Project No. 21482114

**RESPONSE TO GEOTECHNICAL PEER REVIEW COMMENTS FROM GEMTEC
PROPOSED RESIDENTIAL DEVELOPMENT
3930 AND 3960 RIVERSIDE DRIVE, OTTAWA, ONTARIO**

A geotechnical peer review was completed by GEMTEC on behalf of the City of Ottawa and the relevant comments were provided in GEMTEC Letter no. 100008.025 – Rev0, dated Dec 7, 2023. The comments are noted below with response from WSP.

Title: Cross Section B-B
File Name: 21482114_Section B-B_1m higher_MG.gsz
Name: Static Drained
Method: Morgenstern-Price
Horz Seismic Coef.: 0

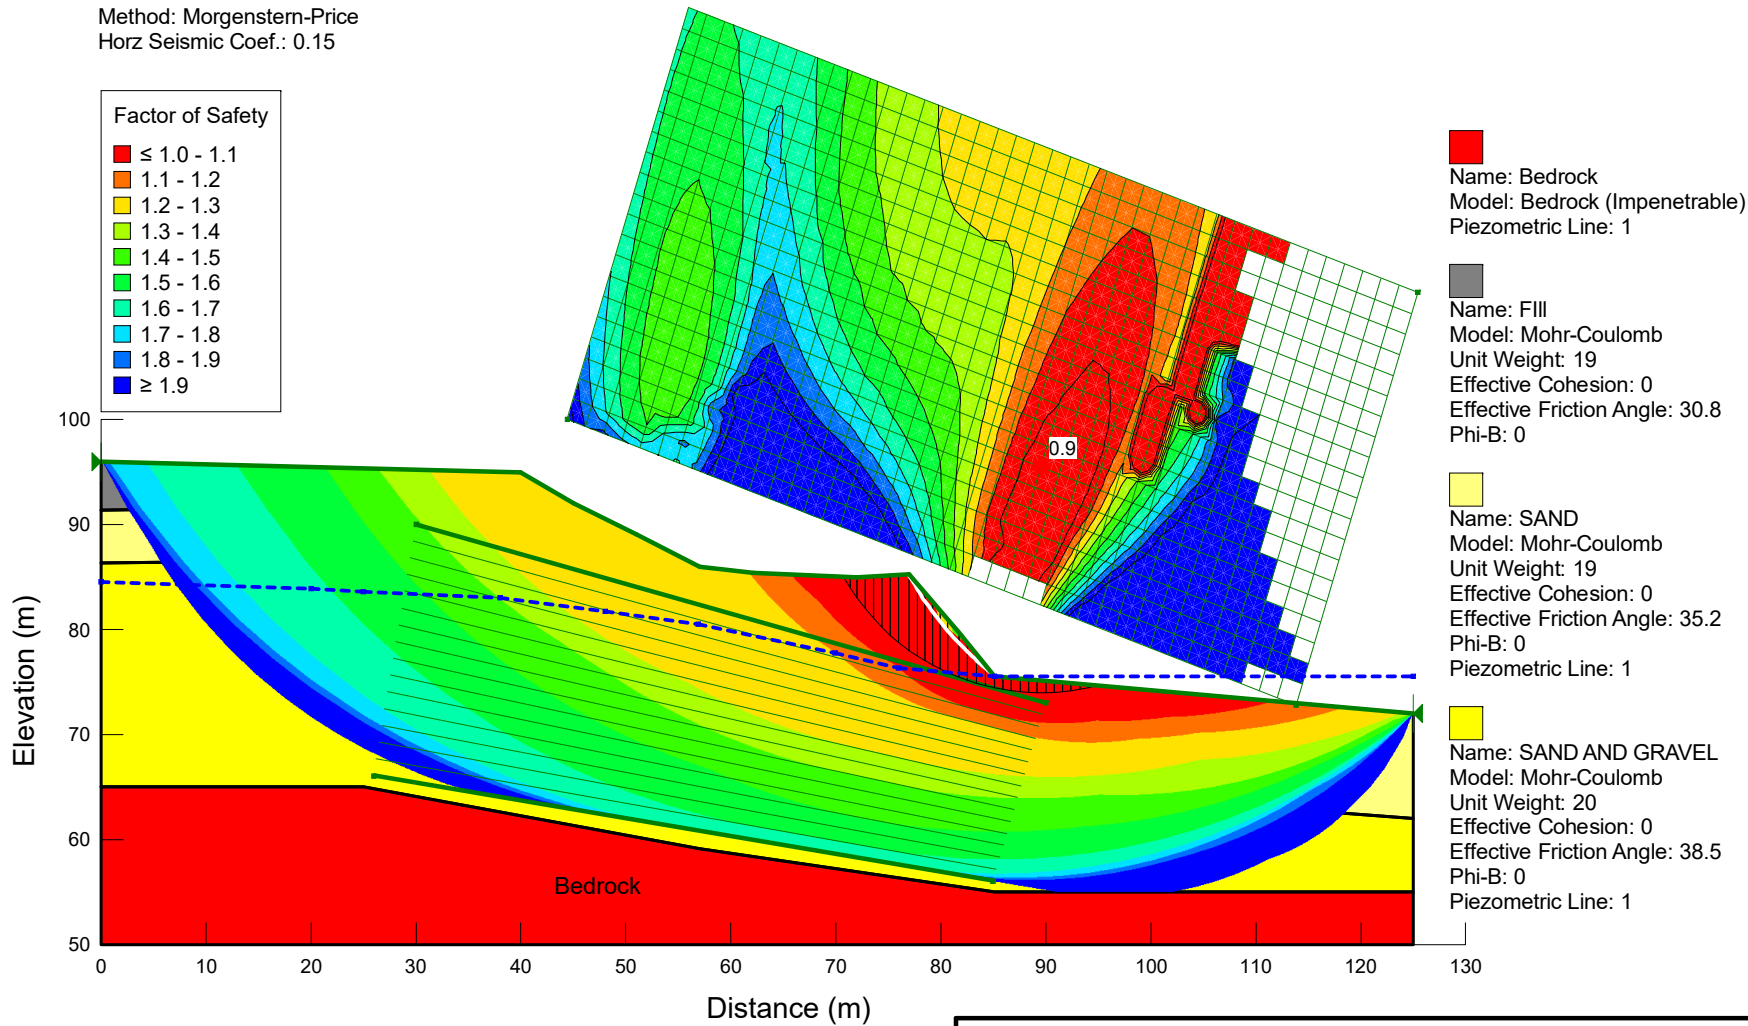
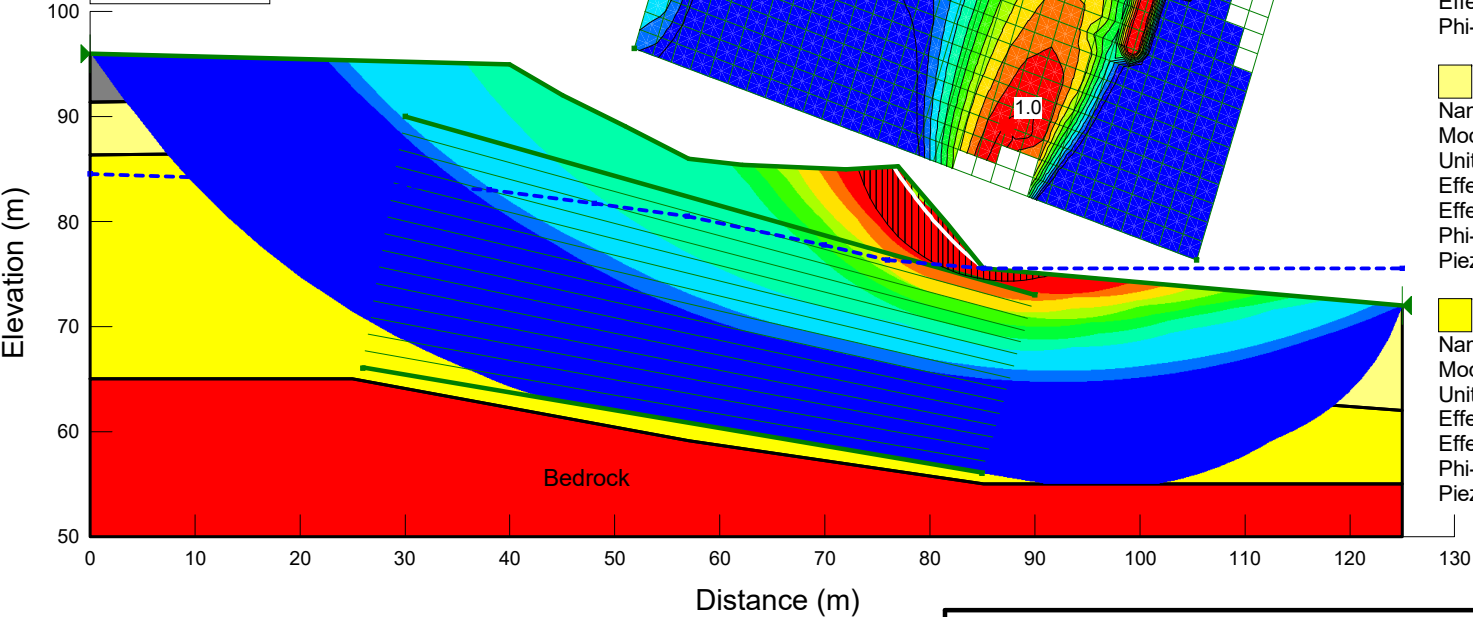
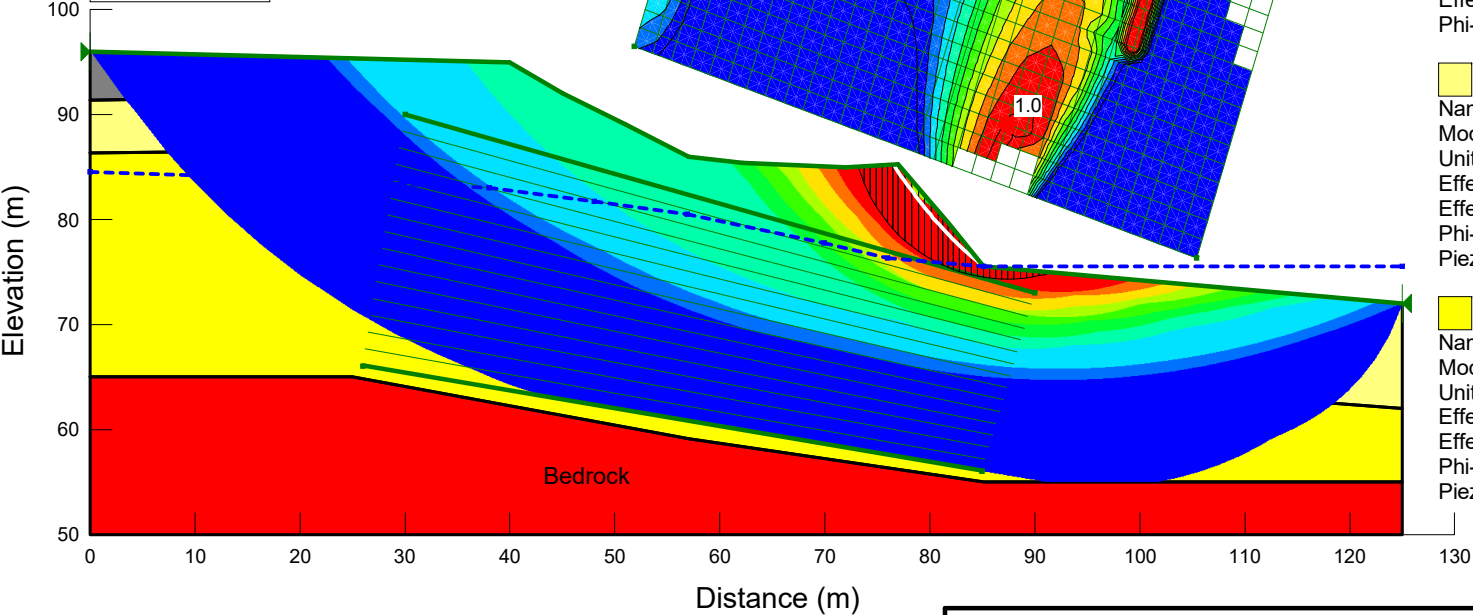
- 4) “The following comments are provided for the slope stability analysis carried out for Sections A-A', B-B', C-C', and D-D'. The safety map for the static and seismic analyses for the values of less than 1.5 and 1.1 respectively, extends past the upper edge of the point grid (for the slip circle centre), which may indicate there are slip circles with those factors of safety or less that extend horizontally farther than currently shown. This could potentially result in an increased stable slope allowance, and it is suggested that the model geometry be revised (by extending the point grid) to check the limits.”

- 5) “The groundwater level assumed in the static analyses for the South Area is at the base of the existing fill (i.e., at elevations of about 82 to 83 m) and is indicated to be based on the water levels measured in the various monitoring wells at the site. This would be Case 3 as outlined in the slope stability guidelines and may not be a realistic assumption. The fill materials above the native sands are not uniform in composition and contain cohesive layers and materials with high silt and clay contents that will tend to retain water and therefore it may not be reasonably conservative to assume the fill materials are fully drained as assumed in the slope stability analyses. The water levels summary in Section 4.1 of the report notes that: “In the South Area, the groundwater level was generally found to be between 12 to 16 m depth (i.e., between elevations of about 75 to 83 m), but as shallow as about 6 m (i.e., elevation of about 88 m).”

Response – *The models for the sections identified above were revised (by extending the point grid), no differences have been observed in the stable slope allowance.*

Response – *While the water level in the south area was recorded to be between elevations of 75.1 and 87.6 m (in monitoring wells as well as from CPT Dissipation testing), it was generally found to be below elevation of 79 m. Only one single borehole location had a higher water level of 87.6. We therefore feel that the original assumptions regarding groundwater level are reasonable assumptions for the overall groundwater depth in the area of interest. Nonetheless, as a precautionary measure and an additional check, the slope stability models for these four sections were revised to take into account for the possibility of a higher groundwater level in South Area by adjusting the piezometric line in the analysis upward in the east side of the site (where the single high level was recorded). This adjustment results in a very minor change to the slope stability (well within the margin of error of the data and assumptions which go into the analysis). The change is of sufficiently small magnitude as to make no meaningful difference to recommended stable slope allowance, and therefore we feel that the originally recommended setbacks may be maintained. The results of the revised slope stability analysis are attached to this memorandum.*
